ZINDORF SUBDIVISION NO. 3

LOCATED IN THE NORTHEAST ONE-QUARTER OF THE NORTHEAST ONE-QUARTER OF SECTION 11, TOWNSHIP 14 SOUTH, RANGE 63 WEST OF THE 6th P.M. EL PASO COUNTY, COLORADO

DRAWING: 21497 FP.DWG PAGE 1 OF 2

DRAWING: 21497 FP.DWG PAGE 2 OF 2

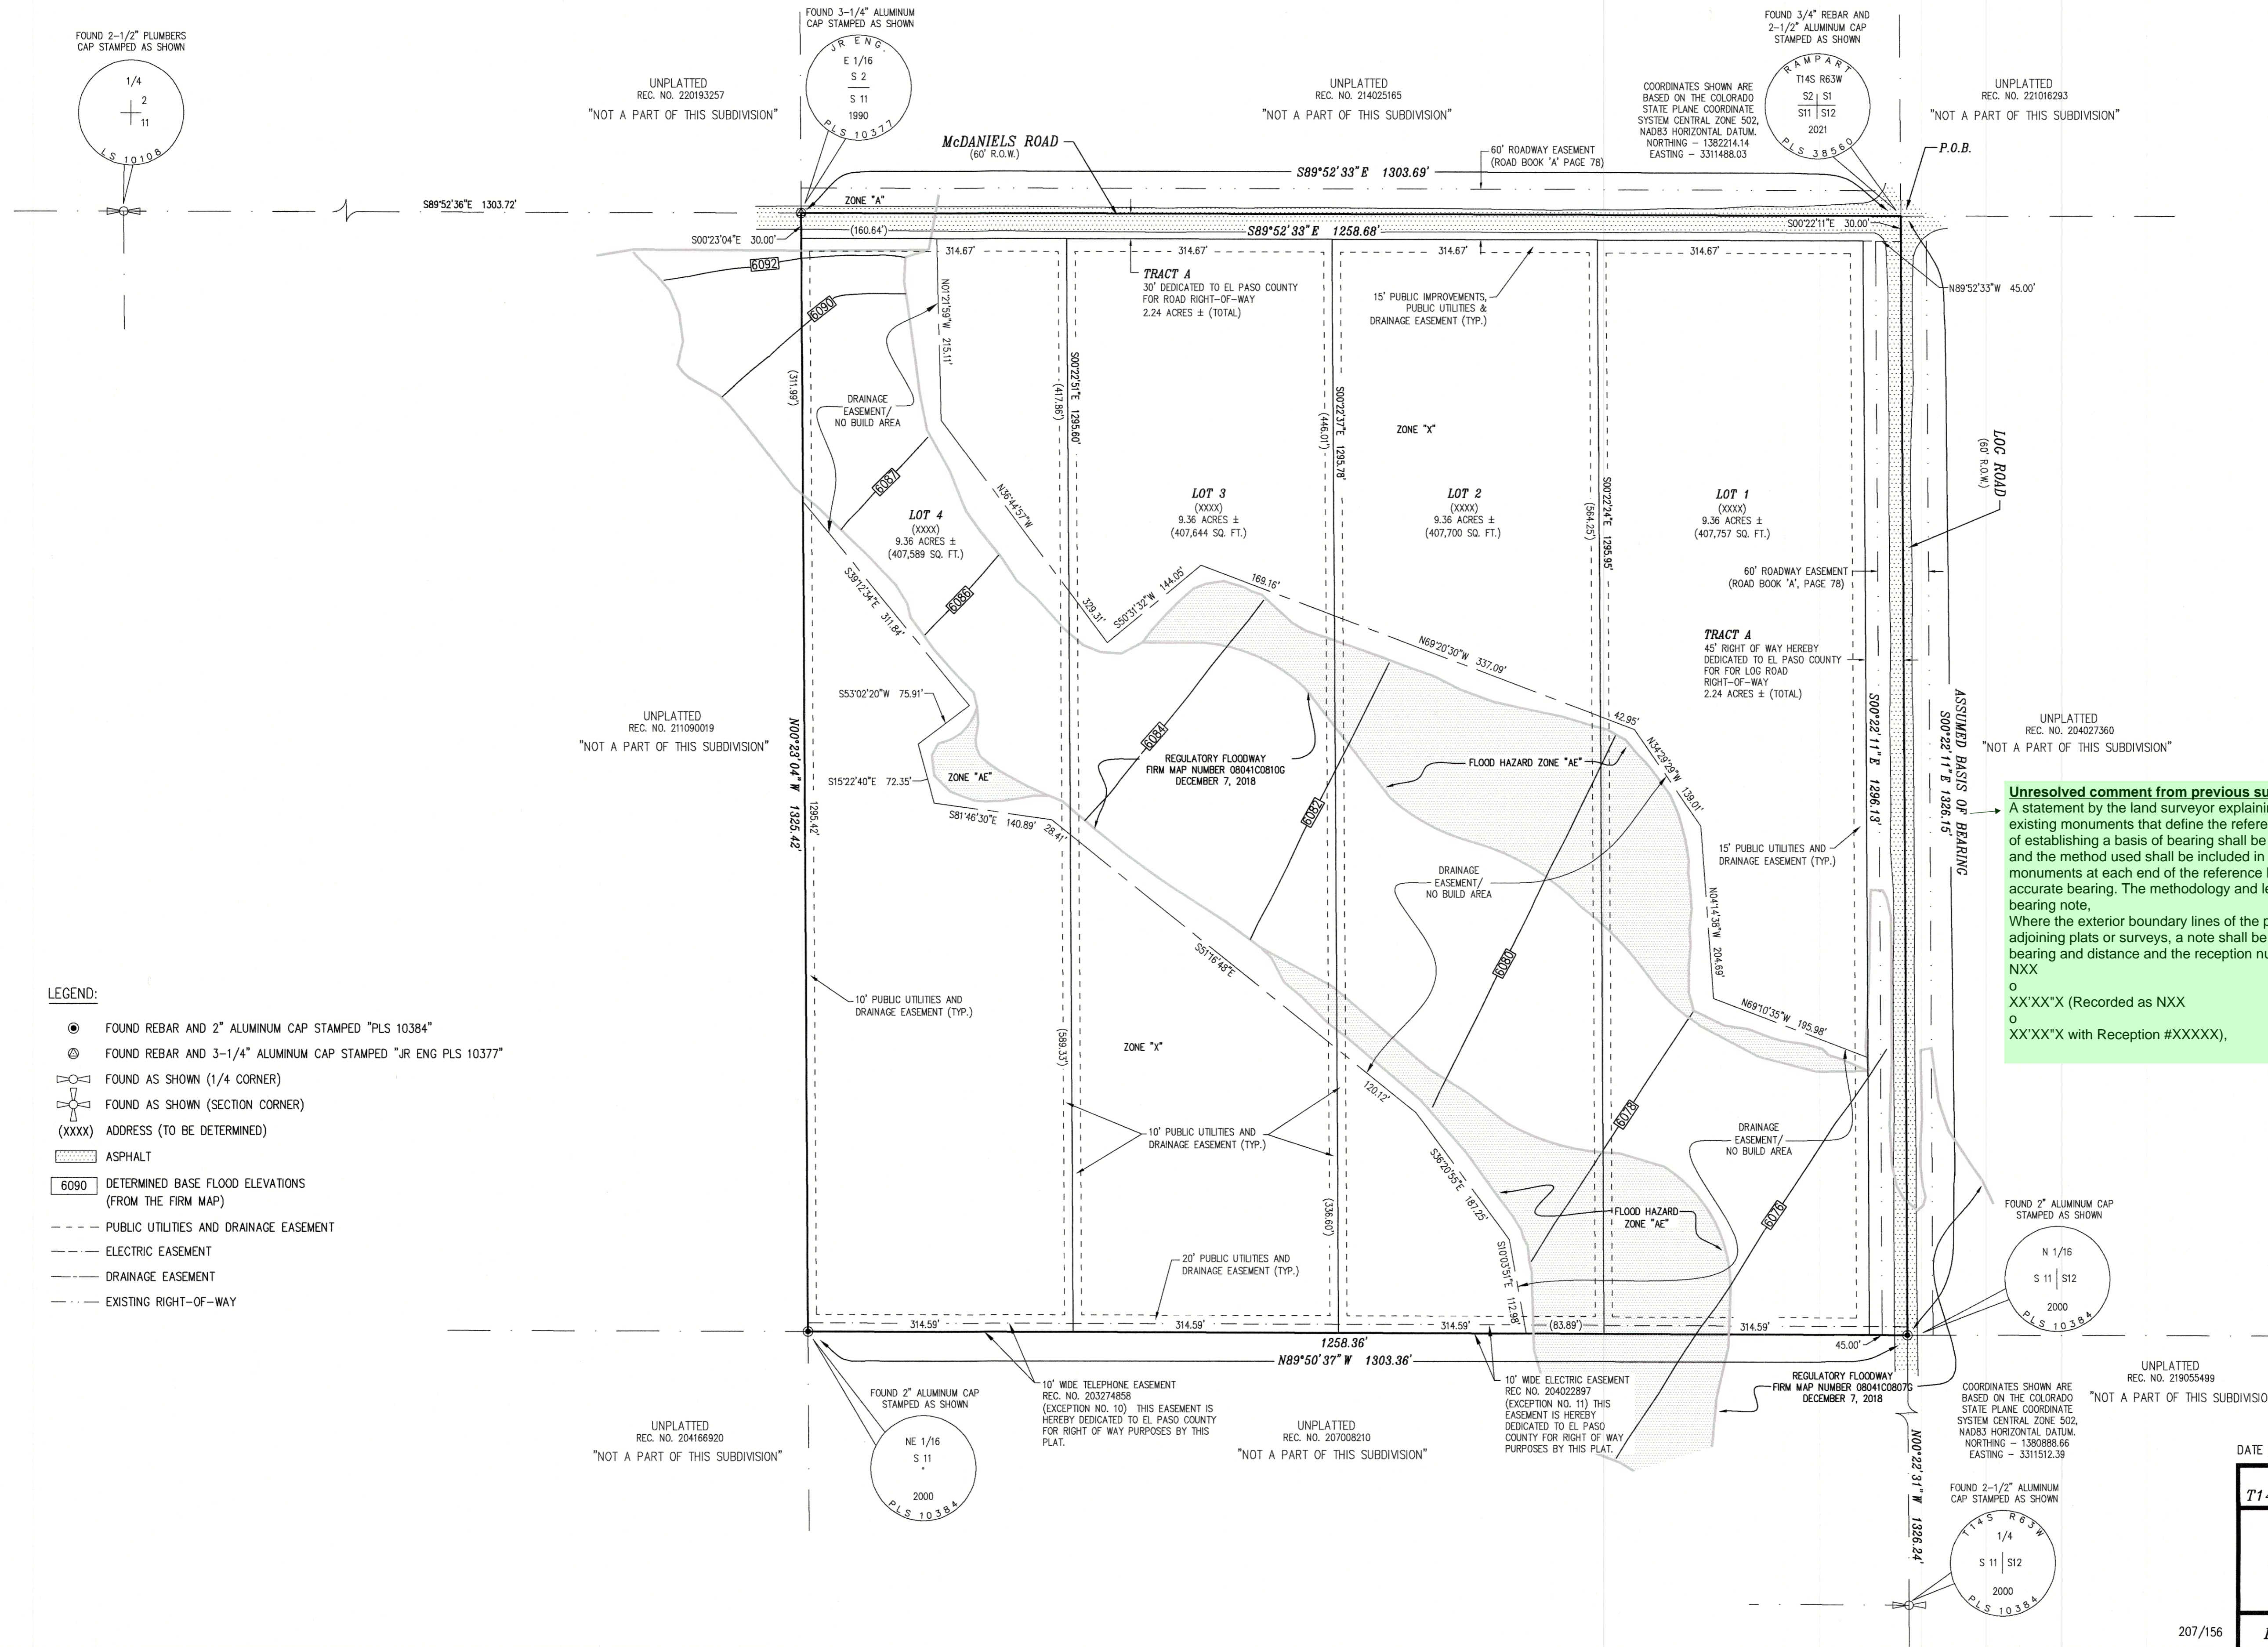
Delete the N/A

Update Note 25 - use this format. Soil and Geology Conditions:
Geologic Hazard Note-Final Plat: (to be customized based upon the individual circumstances)
The following lots have been found to be impacted by geologic hazards. Mitigation measures and a map of the hazard area can be found in the report (Title of Report, generally from the Preliminary Plat file) by (author of the report) (date of report) in file (name of file and file number) available at the El Paso County Planning and Community Development Department:
•Downslope Creep: (name lots or location of area)
•Rockfall Source: (name lots or location of area)
•Rockfall Runout Zone: (name lots or location of area)
•Potentially Seasonally High Groundwater: (name lots or location of area)
•Other Hazard:
In Areas of High Groundwater:
Due to high groundwater in the area, all foundations shall incorporate an underground drainage system.

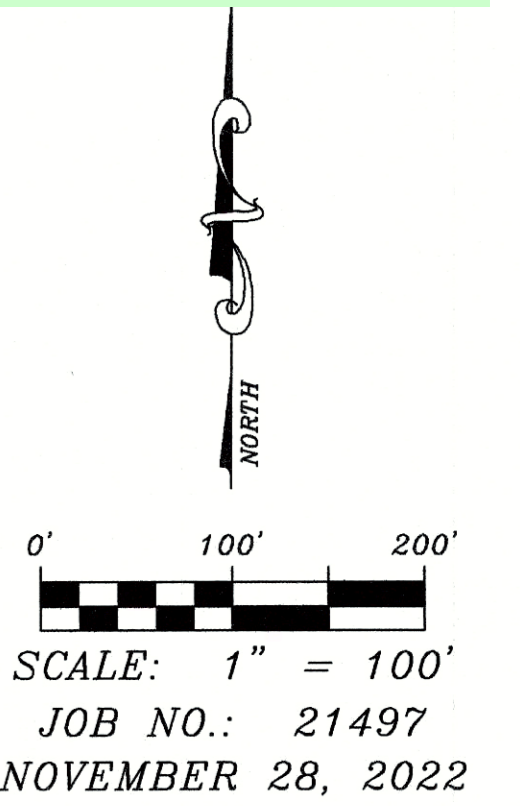
Unresolved comment from previous submittals, please change.
 A statement by the land surveyor explaining the basis of bearing. **Assumed bearings shall not be used.** The existing monuments that define the reference line shall be included on the plat. One of the following methods of establishing a basis of bearing shall be used: (1) solar or polaris observation - the date of the observation and the method used shall be included in the basis of bearing note; or (2) GPS observations on the monuments at each end of the reference line (Note: The observations shall be of sufficient time to ensure an accurate bearing. The methodology and length of the observation session shall be included in the basis of bearing note. Where the exterior boundary lines of the plat show bearings and distances which vary from those recorded in adjoining plats or surveys, a note shall be placed along those lines, in parenthesis, stating the recorded bearing and distance and the reception number of the adjoiners, as shown in the following form:

NXX
 o XX'XX"X (Recorded as NXX
 o XX'XX"X with Reception #XXXXX).
